PROJECT DESIGN PLANS REPORT

NEW BRIDGEWATER BRIDGE

DOC NO: 2024-MCD-0000-REP-PRJ-00006
CLIENT: DEPARTMENT OF STATE GROWTH
PROJECT: NEW BRIDGEWATER BRIDGE PROJECT
LOCATION: BRIDGEWATER, TASMANIA, AUSTRALIA
PROJECT NO: 2024

The report provides a summary of the key changes to the design since the submission of the Major Project Impact Statement submitted on the 4th January, 2022, and demonstrates compliance with various conditions imposed by the Tasmanian Planning Commission in Permit MPP2201.

Figure 27.5.1 – Ramp Cross-Sections

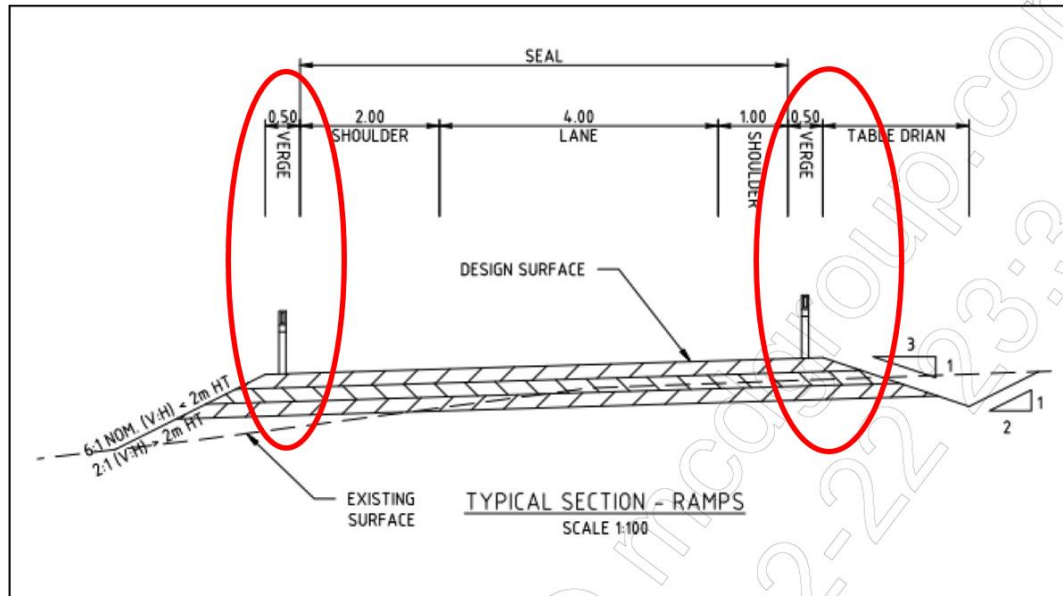
Audit Point 6. Safety Barrier – PSTR Typical Cross Section Fig 27.5.1

The 0.5m verge width indicated for WRSB to be installed is considered to be too narrow. The WRSB deflection width will encroach onto the fill batter that can be at a slope of 2:1. This can adversely affect the crash performance of the WRSB.

Treatment option: Clarify the typical cross section shown with Department of State Growth prior to adopting it in the design.

| Road Safety Audits | | | | McConnell Dowell Constructors | |
|---|--|--------|--|-------------------------------|--|
| 6. | 0.5 verge width for installation of WRSB in the PSTR does not appear to be consistent with current guidelines. | N/A | Clarify with Dept of State Growth. | Reject | The posts within the PS&TR are actually guide posts, not WRSB. Nonetheless, WRSB is not proposed to be used along ramps. GF is the preferred barrier treatment |

Audit Point 15. SUP/Bike Lane

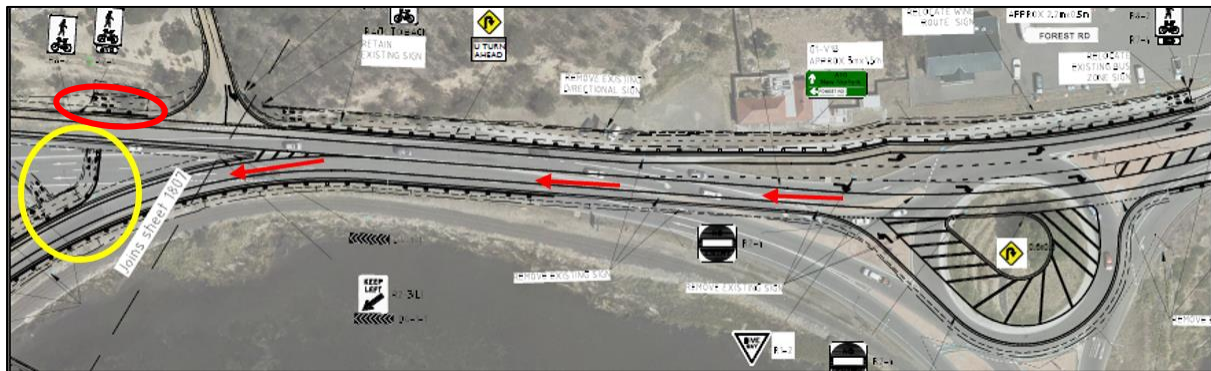
There is currently a bike lane on Lyell Highway for cyclists wanting to access the existing Bridgewater Bridge. The design does not appear to maintain access for cyclists from the west to be able to enter the new SUP connection onto the new bridge. It is not obvious as to how a cyclist from the west would be able safely access the SUP providing access to the new bridge.

Another note is the guard fence length along the SUP shown highlighted by the red circle is too short to be effective as a barrier.

Treatment option: Review and clarify how bicycle access will be facilitated for riders from the west wanting to access the SUP and onto the new bridge.

Audit Point 20. Signs and Linemarking

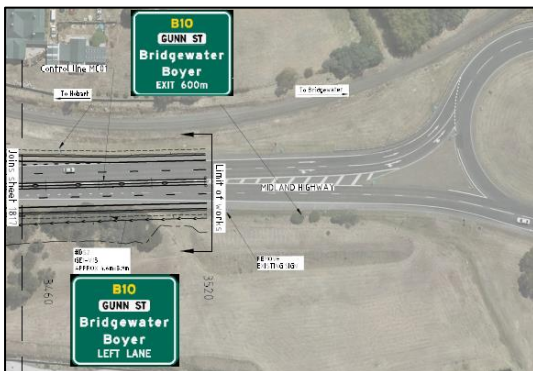
Proposed direction signs to Gunn Street, B10 on Midland Highway (eastbound) are located too close to each other.

Treatment option: Review and omit one of the signs as they essentially provide the same information.

Audit Point 21. Signs and Linemarking

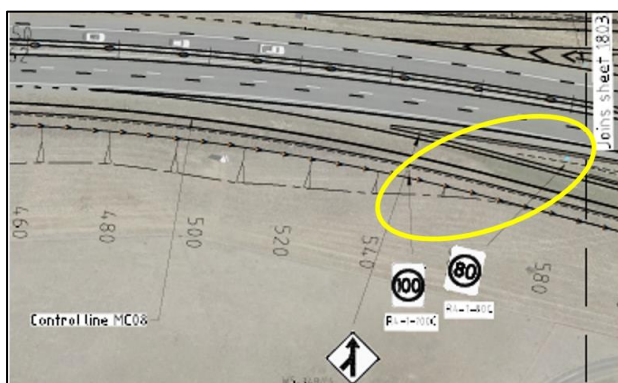
There is no direction/destination sign proposed at the top of the T intersection facing traffic approaching from Old Main Road.

Treatment option: Install direction/destination sign. The sign will also improve delineation and improve conspicuity of the terminating leg at the intersection.
